IDAP REPORT

Property:	38 Chisholm Street, Belfield Lot 12 DP18628 DA2022.105
Proposal:	Partial demolition of the existing detached garage and construction of an attached secondary dwelling.
Applicant:	A Amirashairi
Owner:	Tuan Anh Tu
Date of lodgement:	20 July 2022
Notification period:	27 July 2022 – 10 August 2022
Submissions received:	Nil
Assessment officer:	W van Wyk
Estimated cost of works:	\$80,000.00
Zoning:	R2-Low Density Residential - SLEP 2012
Heritage:	No
Flood affected:	Yes
Is a Clause 4.6 Variation Proposed:	No
RECOMMENDATION OF OFFICER:	APPROVAL

Development consent is being sought for the partial demolition of the existing detached garage and construction of an attached secondary dwelling.

Figure 4: Proposed Secondary Dwelling Ground Floor Plan

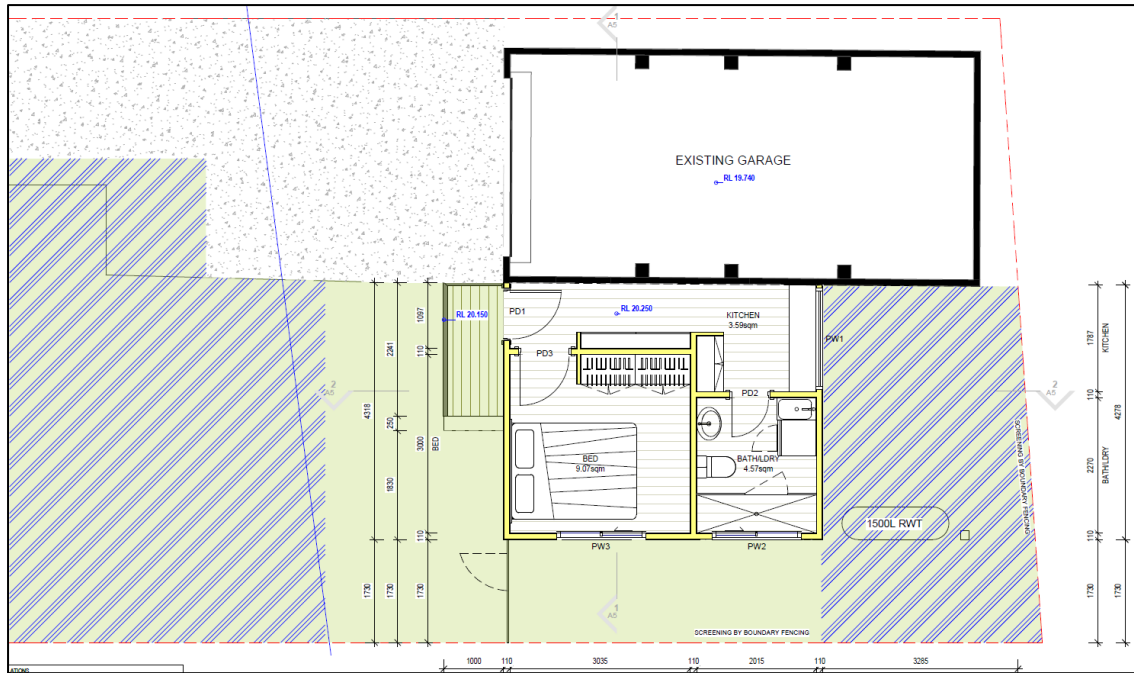
However, due to the location to the south of the existing garage, the internal areas of the proposed secondary dwelling are unlikely to achieve compliant solar access. This is considered acceptable in the circumstances given the lot orientation, existing garage and compliant setbacks.

The ground level of the secondary dwelling was dropped by 250mm to RL 20.250 at the request of Council to minimise potential overlooking. This is only 0.3m higher than the ground level along the rear boundary. Accordingly, the existing 1.8m boundary fence is considered sufficient to retain privacy across the side and rear boundaries. In any event, the kitchen window has a narrow form and the bedroom and bathroom are well set back (1.73m). It is noted that impacts from bedrooms are considered less significant as these are low active use rooms.

Roof Overhang	The secondary dwelling roof overhang towards the rear boundary is to be removed.
Timber Privacy Screen	The timber privacy screen proposed to separate the private open space of the primary and secondary dwellings is to be 1.6m above existing ground level.
Existing Deck Roof	The roof over the deck area of the existing dwelling is to be demolished to match the approved demolition of the deck itself.

Figure 14: Landscape Plan showing principal POS of each dwelling

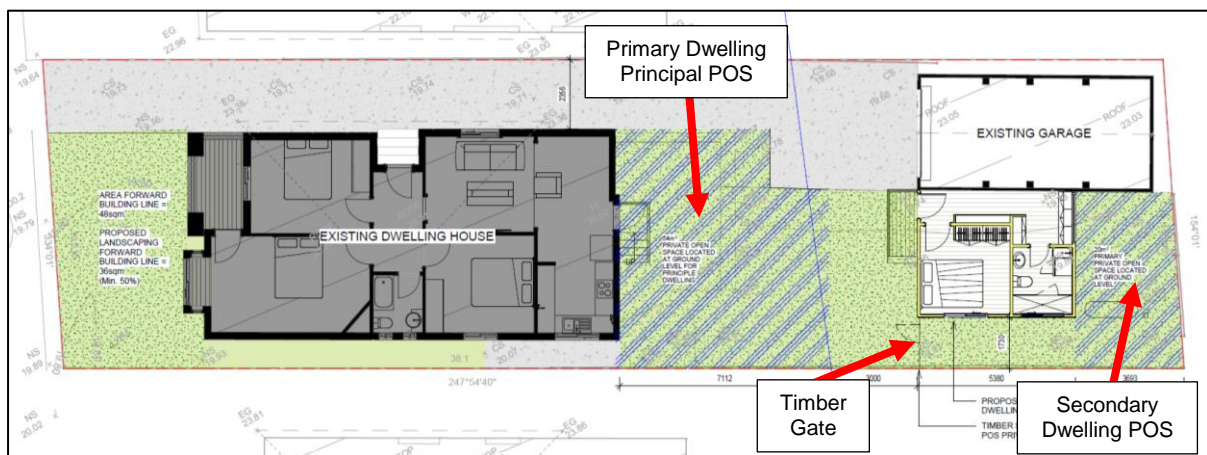
The proposal retains in the order of 54m² principle private open space for the primary dwelling which is considered acceptable. Adequate privacy measures are also incorporated between this space and the POS of the secondary dwelling. This includes the secondary dwelling being positioned between the two POS areas and the incorporation of a timber screen gate (see **Figure 14**).

POS is provided at existing ground level for the proposed secondary dwelling at the rear of the site. The area with a minimum dimension of 3m is 20m², however 1m² of this comprises the water tank and another portion is taken up by plantings which are to be retained. Overall however, the area remains sufficient, being over the 12m² control. The location is acceptable as well, receiving reasonable solar access given the existing garage in the north western corner.

Direct access to the private open space is not provided. Rather, occupants would need to exist the front door, travel down two steps and then walk around the southern side of the secondary dwelling, through the privacy gate. While this is unfortunate, it is a better outcome than design alternatives, which include the POS of the two dwelling directly adjoining each other or providing a raised platform outside the kitchen which would have privacy impacts on the neighbour. Similar to the amenity comments in the solar access section above, strict compliance is not always possible or reasonable. The access to the POS is considered acceptable in this instance.

A final consideration is the privacy of the POS. As the area will not be directly accessible from inside the secondary dwelling, it is likely generate less privacy impacts. The proposal is not significantly different from the existing situation, where the private open space of the dwelling extended to the rear boundary. The existing 1.8m boundary fence and landscaping also assist in providing suitable screening as per the SCDCP 2005.

There will be a privacy benefit from the removal of the elevated deck attached to the existing dwelling, particularly across the side boundaries. Privacy between the POS of the primary and secondary dwellings will be achieved through a timber screen gate. As no dimension is provided on the architectural drawings, the gate will be conditioned to a height of 1.6m.
